T. KARIDAS
File No: SP12-033184

TO:	CHAIR AND MEMBERS – PLANNING AND ENVIRONMENT COMMITTEE MEETING
FROM:	G. KOTSIFAS P.ENG. MANAGING DIRECTOR, DEVELOPMENT & COMPLIANCE SERVICES AND CHIEF BUILDING OFFICIAL
SUBJECT:	APPLICATION BY: BANMAN DEVELOPMENTS (WEST) INC. 2095 CORONATION DRIVE PUBLIC SITE PLAN MEETING FEBRUARY 26,2013

REQUESTED ACTION: Application for Site Plan Approval for a 102 unit cluster townhouse development.
--

SCALE HORIZONTAL SCALE 1" = 400' VERTICAL SCALE 1" = 200'	TITLE 2095 CORONATION DRIVE BANMAN DEVELOPMENTS - WEST PARK SITE PLAN	SHEET NO. 1
---	--	----------------

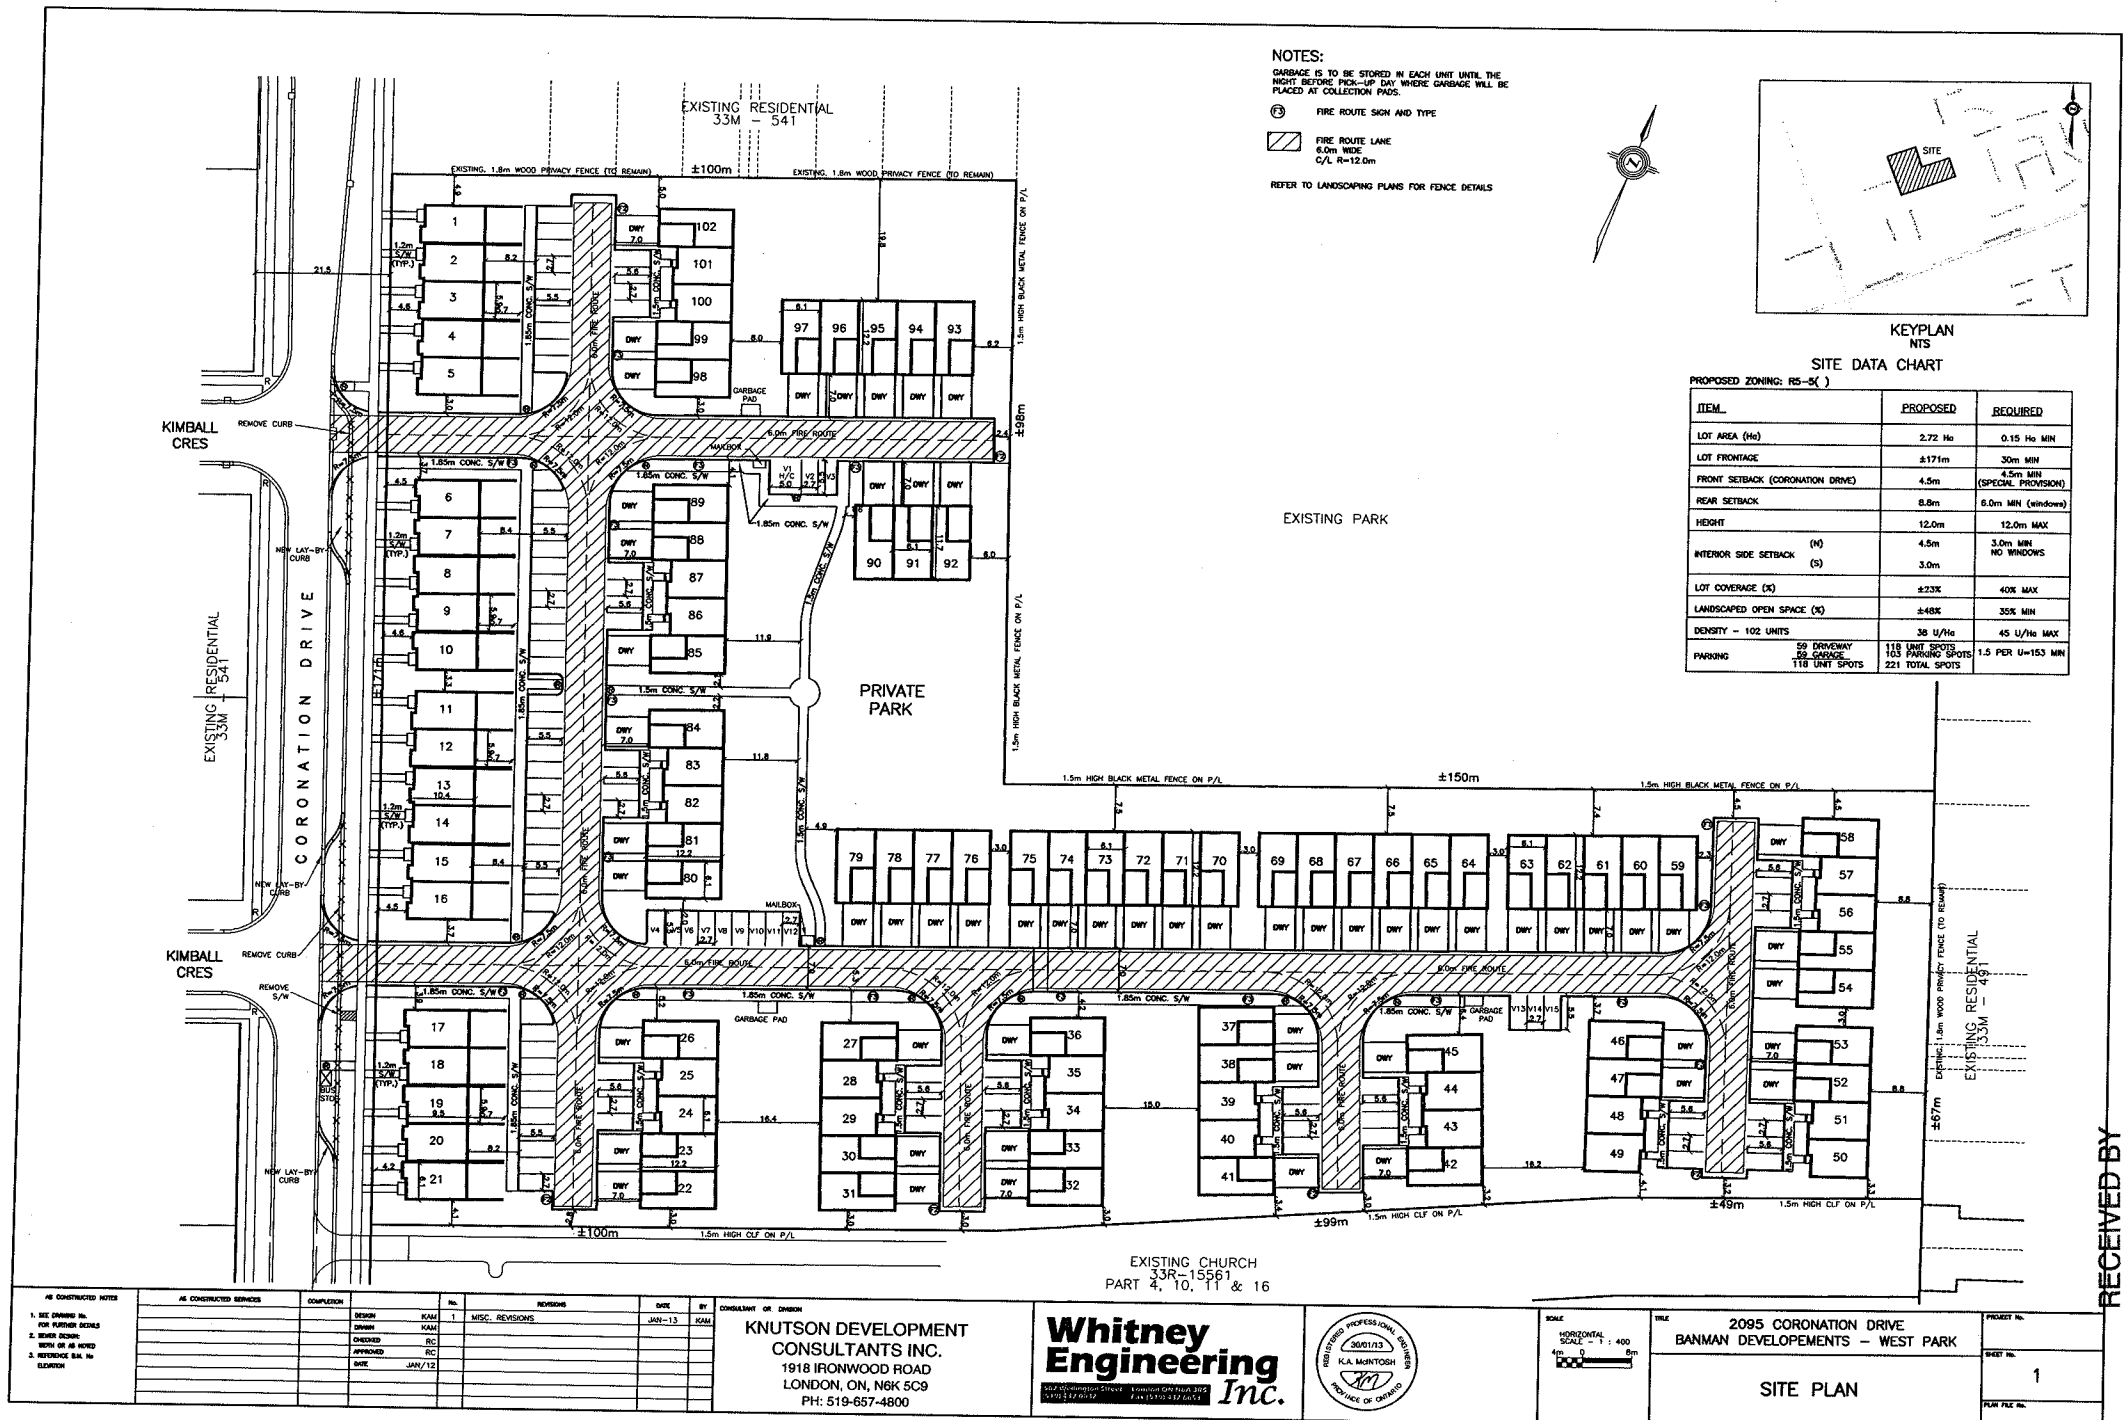
- ii) Minimize points of egress and ingress.**
 There are two points of egress and ingress as shown on the attached Site Plan.
- iii) No garages fronting onto Coronation Drive.**
 There are no garages fronting onto Coronation Drive.

- vi) Fencing around the perimeter of the park to be low in height and of a high quality e.g. decorative black iron.**
 The proposed fencing is 1.5m high black wrought iron (iron eagle) fence. (as shown on the latest site plan and landscape plan). This meets the minimum height for a fence abutting a Park.

TITLE	2095 CORONATION DRIVE BANMAN DEVELOPEMENTS - WEST PARK	PROJECT NO.	
	GRADING PLAN	SHEET NO.	2
		PLAN FILE NO.

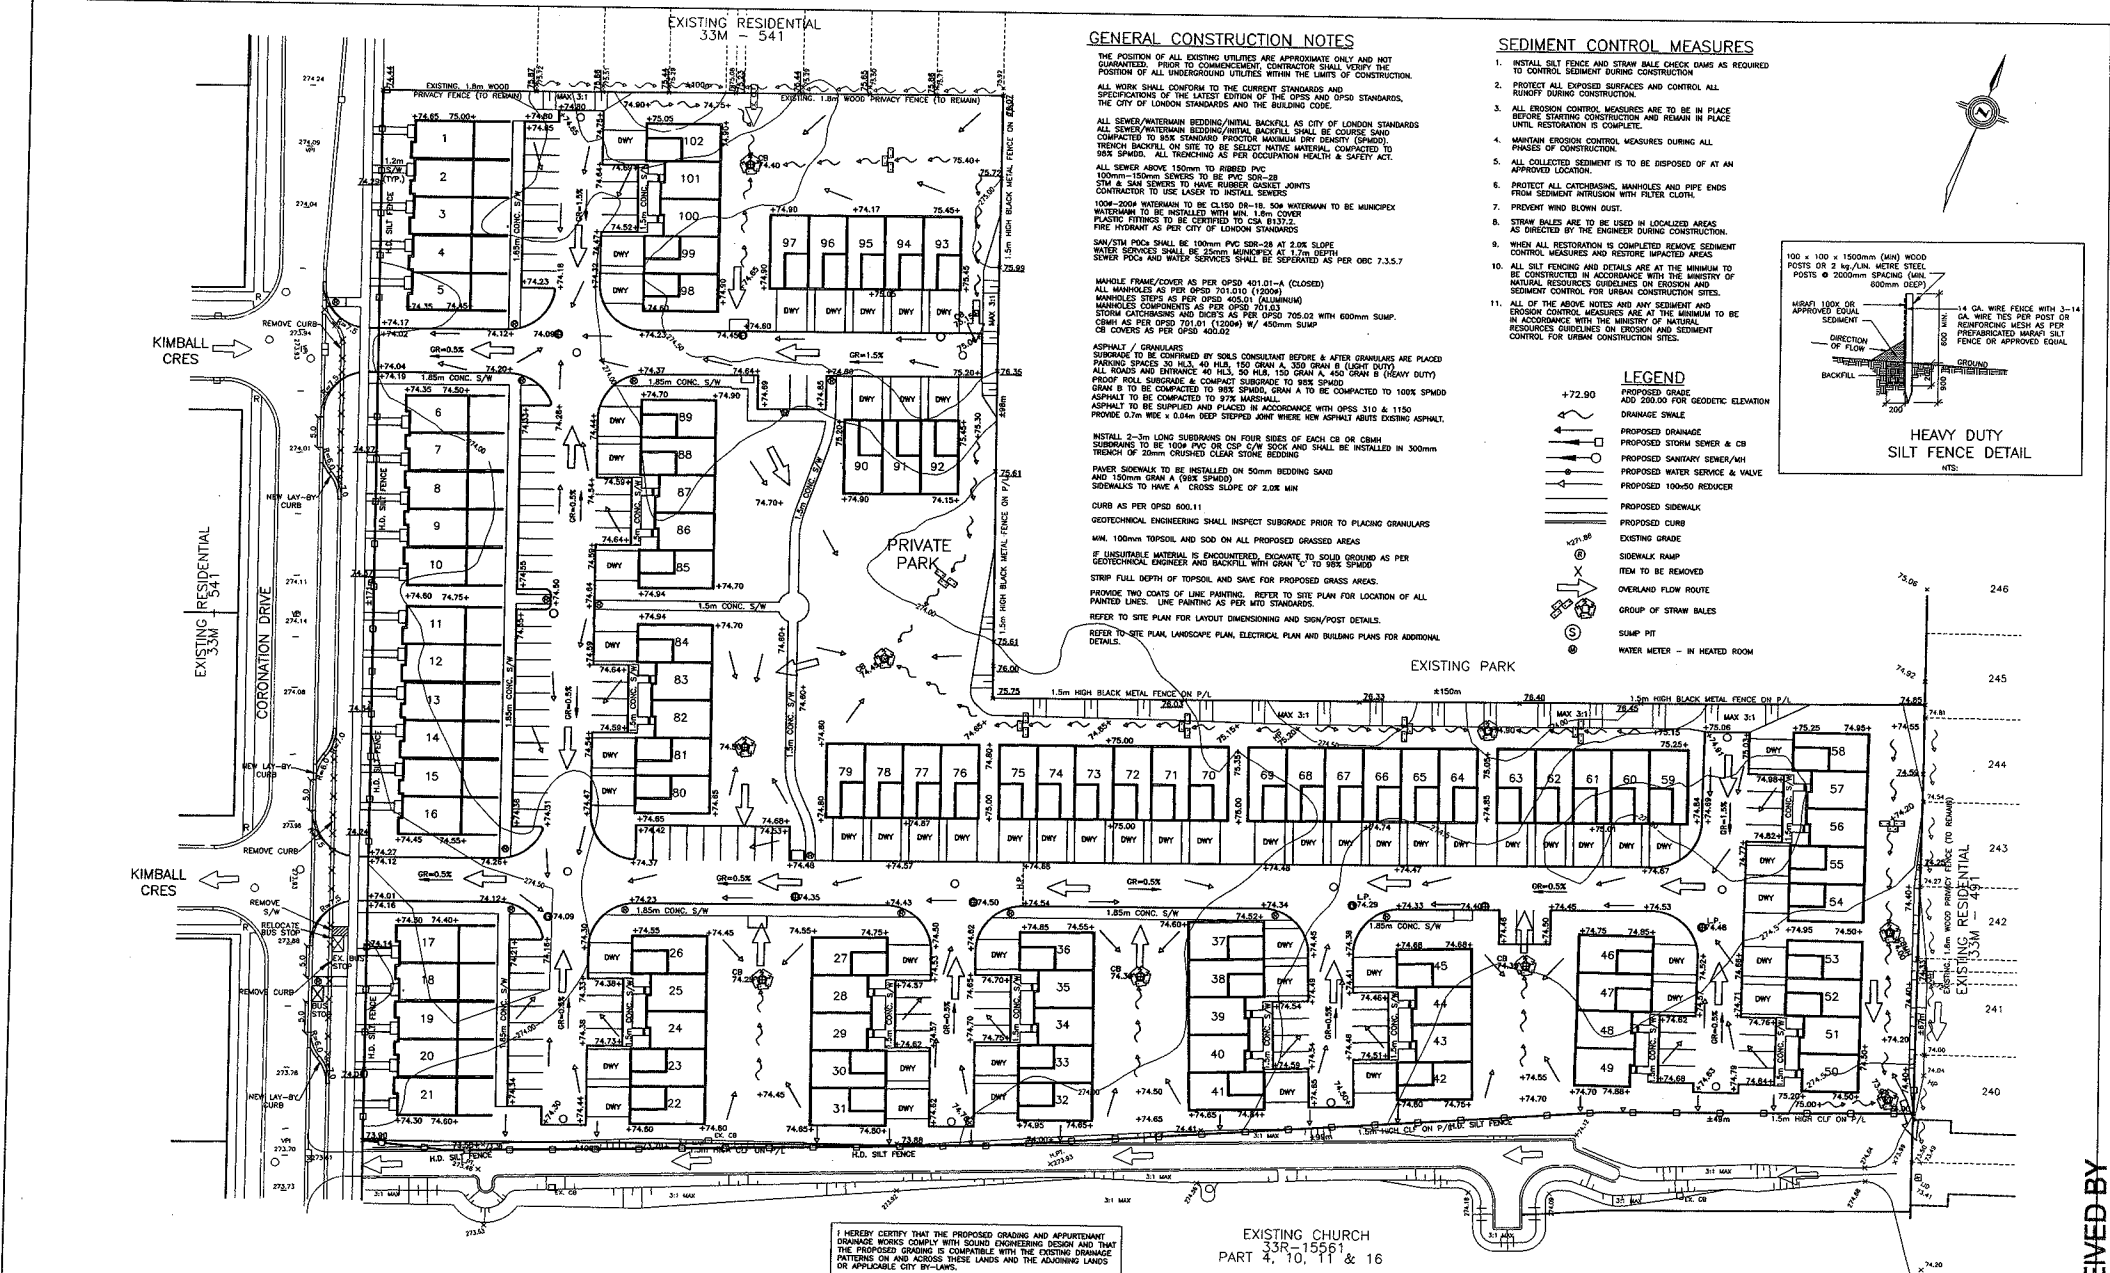
- xv) Ensure the property is graded to not flood the neighbouring properties.**

Grading plans are under review by Engineering Review. Generally, the surface run-off will be directed to the storm sewer system on the site and generally contained. Neighbouring properties should not be affected by the design.

OVERALL LANDSCAPE PLAN

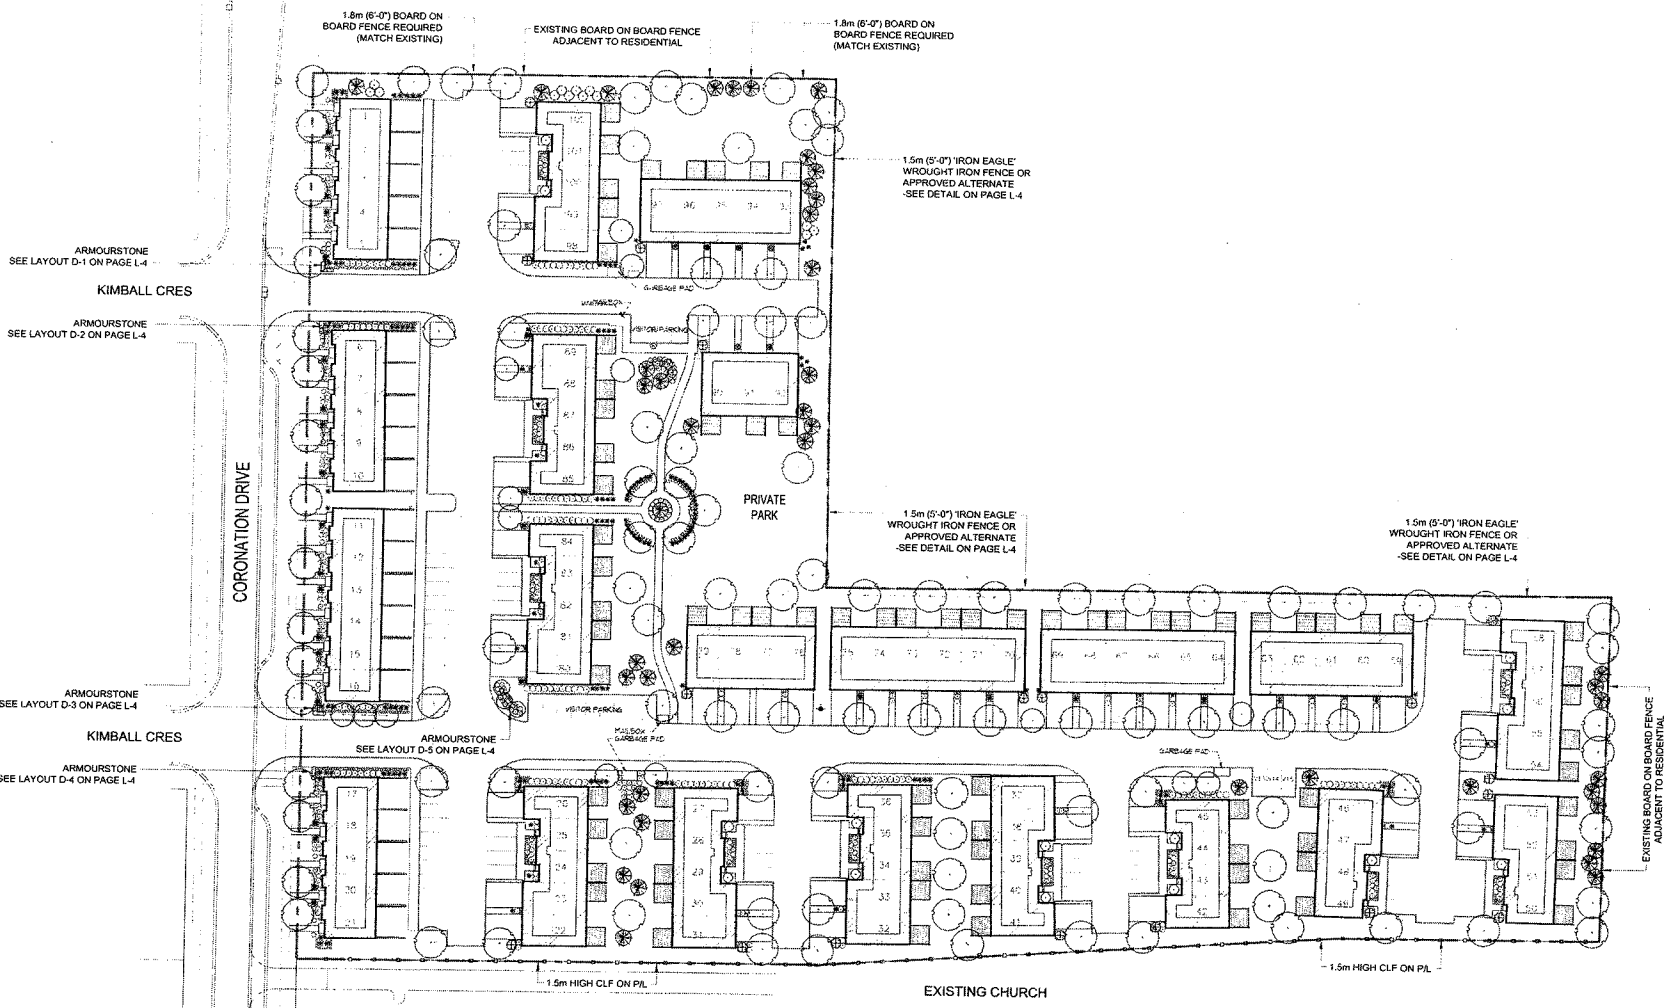
- xii) Privacy for residential properties to the north and east of the site should be considered.**

Privacy fencing (1.8m high wood fence) and landscape materials will screen the adjacent residential properties. Additional plantings will be added to implement this.

FRONT BLOCK (FROM CORONTATION DRIVE)
CORONATION CONDO UNIT (JAN.14/13)

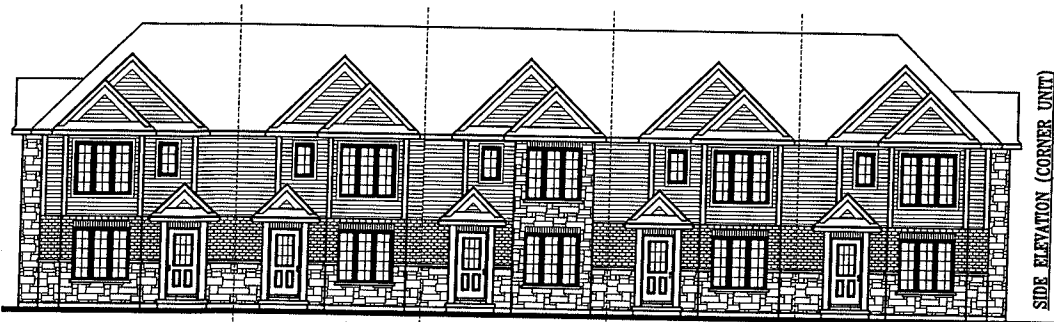
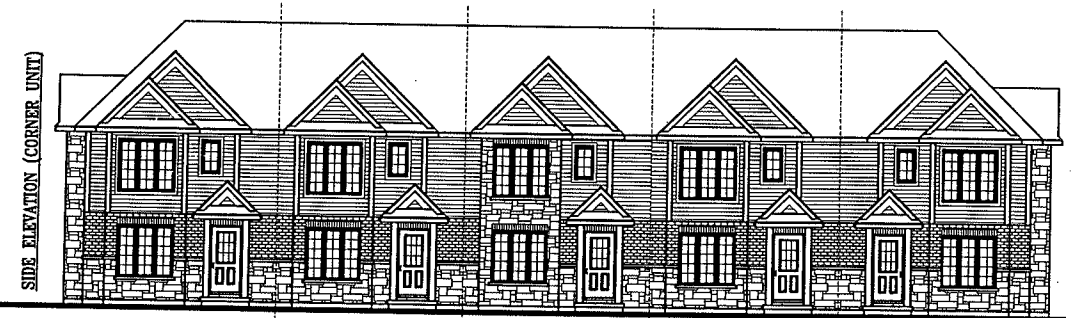
- iv) Corner units at the intersection of the private road and Coronation Drive to incorporate the same building form, architectural elements as those units seen from the street to create a gateway effect.**
 As shown on the proposed building elevation drawings, the corner units create a gateway effect.

- xiii) Incorporate architectural variations in the individual units of the elevations on the street and park frontages.**

The buildings that face Coronation Drive have been improved with the middle unit of each building having a stone element from the ground to the eave, as well as having the siding incorporate tonal differences in the units that face the park.

REAR ELEVATION (TYP. UNIT BLOCK FROM PARK 59-79)
CORONATION CONDO UNIT (JAN.14/13)

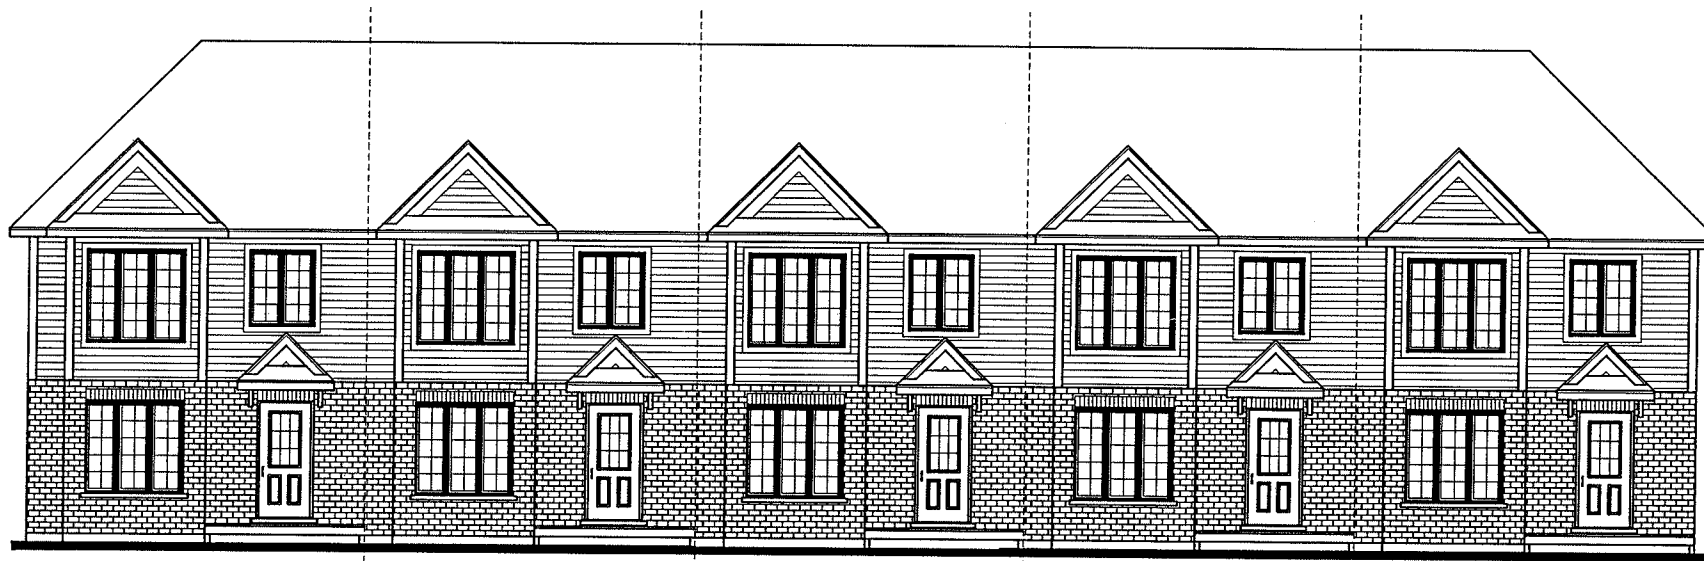
- v) Buildings shall be located to frame the public Park and architectural elements such as principle entrance doors and windows are to be located on building facades facing the park.**
 This has been addressed by the use of man doors as well as a decorative porch feature on all units adjacent to the park. (see attached drawing).

- xiv) Limit the maximum deck heights to no higher than the first finished floor level for each dwelling unit.**

This has been addressed as a special provision in the Zoning By-law and decks will be added to the elevation drawings to confirm this.
